This document responds to the general comments and specific comments that were presented on the Meeting Agenda for the Florida Building Commission, Energy Technical Advisory Committee meeting, dated September 27th 2018. Responses are prepared by Integrated Environmental Solutions Ltd.

Comments from **Muthusamy Swami**, Director, **Simulation Software Development** at **Florida Solar Energy Center (FSEC)**: www.floridabuilding.org/fbc/commission/FBC_1018/Energy_Tac/IES_SoftwareReview_Findings.pdf

Figure 2: Example Reports from IESVE Software

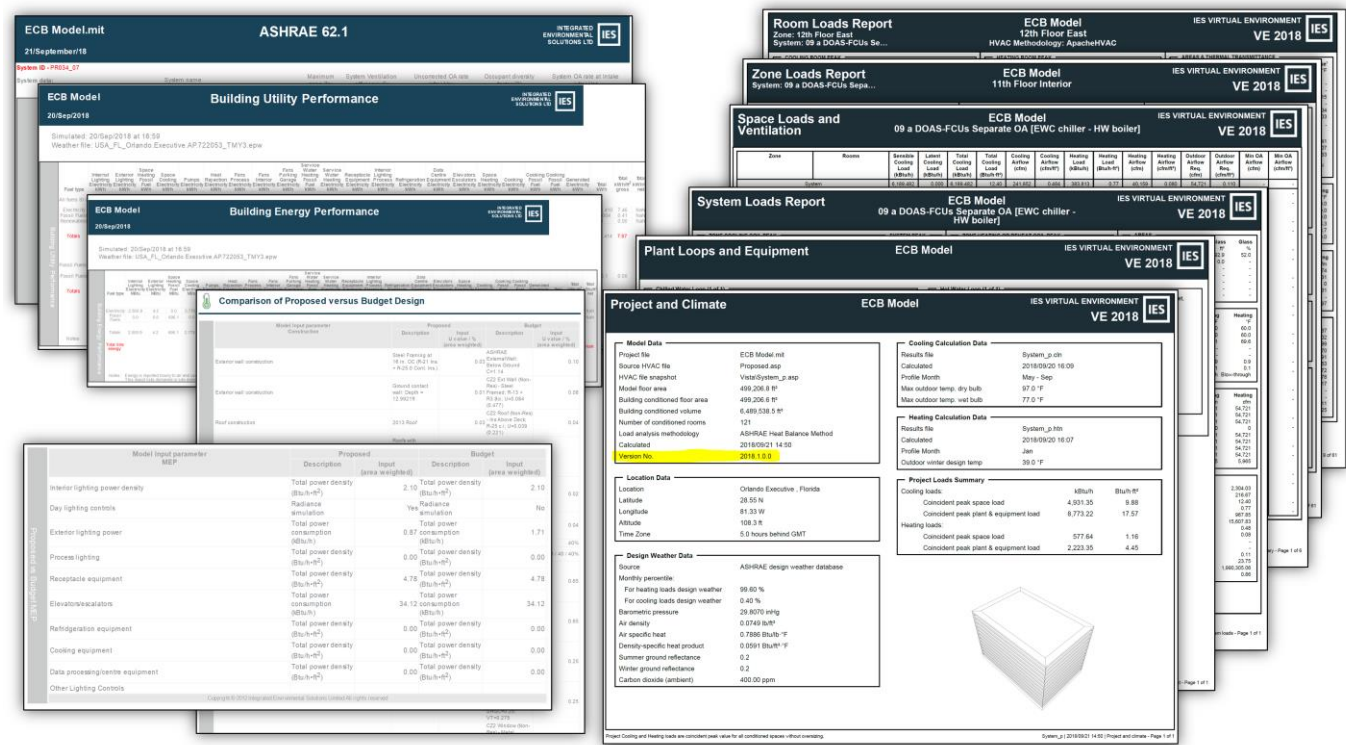
C-3 (continued) by Dr. Swami	
Issue/Comment: Compliance Certification Box. Check box and signature box for Owner, Builder, registered design professional, and Building Commission Code Official are missing from the compliance report form. Version Number of the software is also missing in the compliance report.	Response: Signature box is included for the Owner, Builder, registered design professional, or Building Commission Code Official on the compliance report form. There is ample space in the report for any additional signatures, stamp, and other officials' information. The software version number is included on multiple input reports and can be added to the ECB compliance report. Examples are shown in Figure 02.

C-4 (continued) by Dr. Swami	
Issue/Comment: Building Input Summary Report No minimum building input summary report is included in the sample compliance report.	Response: IESVE software does provide various building input summary reports for the building, plant, HVAC systems, thermal zones, rooms, building envelop comparison, internal gains comparison, schedules, etc. Some examples are shown in Figure 02.
